Initial Response to Public Comments from the June 8, 2021 Public Meeting

OPA-2021-02, ZBA-2021-02, SUB-2021-01
 Shining Hill Estates Collection Inc. c/o Malone Given Parsons Ltd.
 August 20, 2021

Figure 1: Before and after. Upon completion, this is now one of the largest underground stormwater detention systems in North America.

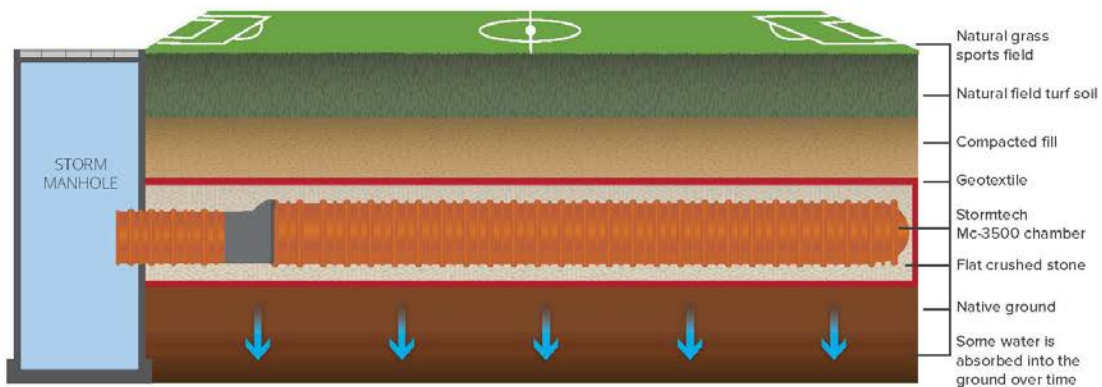
<p>14. Why can't we see the design of the stormwater cell?</p>	<ul style="list-style-type: none"> - Details regarding the stormwater management facility will be designed once the location has been settled. - Exemplary images follow.
<p>15. Slope Stability Report does not correlate to the Plan of Subdivision</p>	<ul style="list-style-type: none"> - The Slope Stability Report will be reviewed and confirmed during the next detailed submission stage. The draft plan of subdivision will be modified if

Examples of underground stormwater management facilities:
